## Report to Sydney Central City Planning Panel

<b>SCCPP reference</b>	PPSSCC-28
<b>DA No.</b>	528/2019
<b>Date of receipt</b>	15 March 2018. Amended plans or information received: <ul style="list-style-type: none"><li>- 2 March 2020</li><li>- 20 August 2020</li><li>- 16 October 2020</li><li>- 24 November 2020</li></ul>
<b>Proposal</b>	Construction of two residential towers comprising 419 apartments over four levels of basement car parking, construction of a new road plus associated landscaping, civil and public domain works
<b>Street address</b>	12 - 14 Birnie Avenue, Lidcombe
<b>Property Description</b>	Lot 1 DP 802479
<b>Applicant</b>	Altus Consulting Group Pty Ltd
<b>Owner</b>	SLA Homebush Pty Ltd and YYS & Co. Pty Ltd
<b>Submissions</b>	Less than 10 unique submissions
<b>Relevant s4.15 matters</b>	<ul style="list-style-type: none"><li>• Environmental Planning and Assessment Act and Regulations</li><li>• State Environmental Planning Policy No. 55</li><li>• State Environmental Planning Policy No. 65</li><li>• State Environmental Planning Policy (Sydney Harbour Catchment) 2005</li><li>• State Environmental Planning Policy (BASIX) 2004</li><li>• State Environmental Planning Polic

Figure11: Location of proposed wind mitigation measures

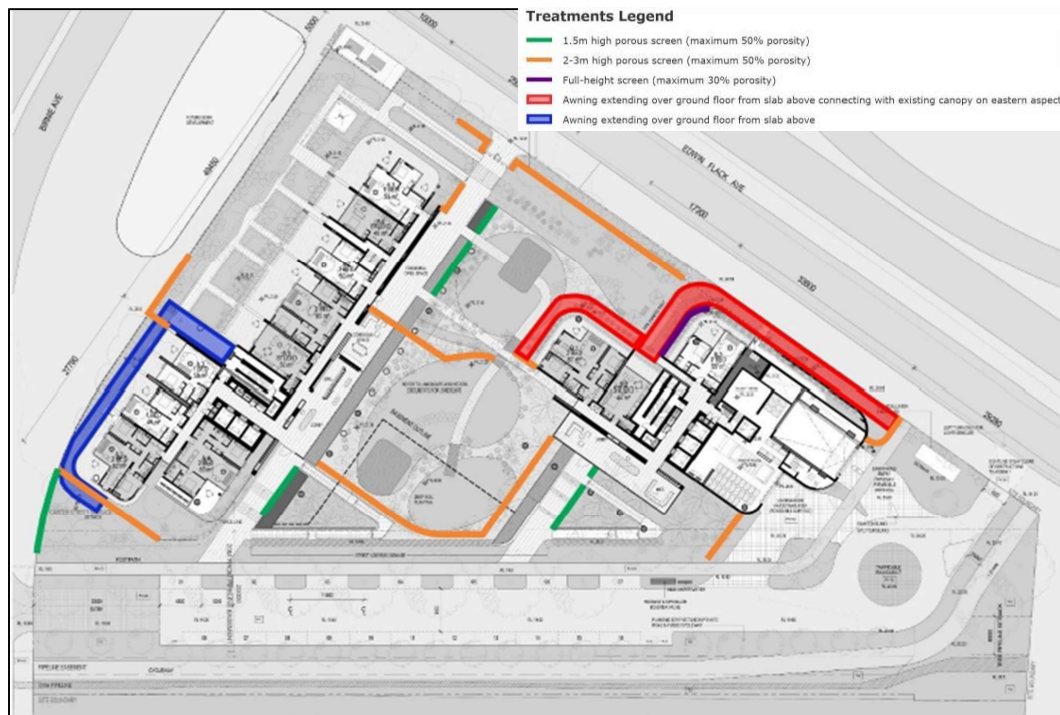
The applicant's wind report was peer reviewed by Council's consultant wind expert. That peer review agreed with the methodology and safety/comfort criteria used, however raised the following concerns:

- The explanation provided for locations 27, 28 and 29 (between the towers) exceeding the comfort criteria is questionable.
- The nominated mitigation measures have not been tested to quantify their effectiveness, which is essential given the multiple and significant exceedances of both comfort and safety criteria. Further, those mitigation measures only respond to windflow that is horizontal to the ground, and do not address downwash from the buildings themselves. Such downwash would reduce the effectiveness of the mitigation measures. Finally, the proposed screens are likely to in fact funnel and accelerate wind through the gaps between the screens.

Discussions between both parties was then arranged to ensure the required revised report responded to those concerns.
